To: Deschambault, Lynda[Deschambault.Lynda@epa.gov]
Cc: Greg Reller (gr@burlesonconsulting.com)[gr@burlesonconsulting.com]
From: Brown, Anthony R (RM)
Sent: Fri 4/7/2017 1:17:36 AM
Subject: Leviathan Mine Aspen Seep Bioreactor Update

From: Deschambault, Lynda [<mailto:Deschambault.Lynda@epa.gov>]
Sent: Thursday, April 06, 2017 4:03 PM
To: Brown, Anthony R (RM)
Cc: Mike Johnson; Greg Reller; Cohen, Adam; Wirtschafter, Joshua; Helmlinger, Andrew; Cory Koger; Chang, Kay SPK; tavassoli, lily; Doug Carey; Black, Ned; Serda, Sophia; Yogi, David
Subject: FW: Leviathan Mine Aspen Seep Bioreactor update

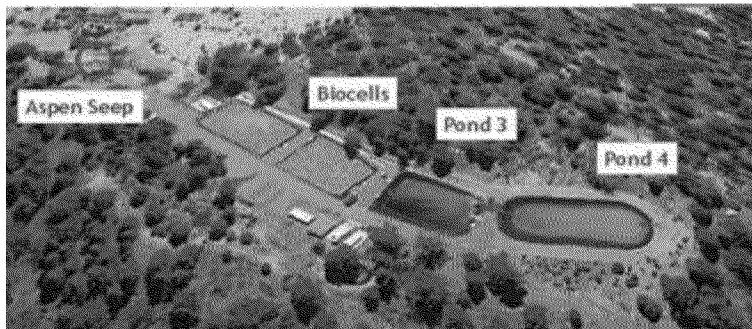
1) **Flow Rates:** Could you please provide some additional updates on charts and figures regarding flow, freeboard etc? For instance this one:
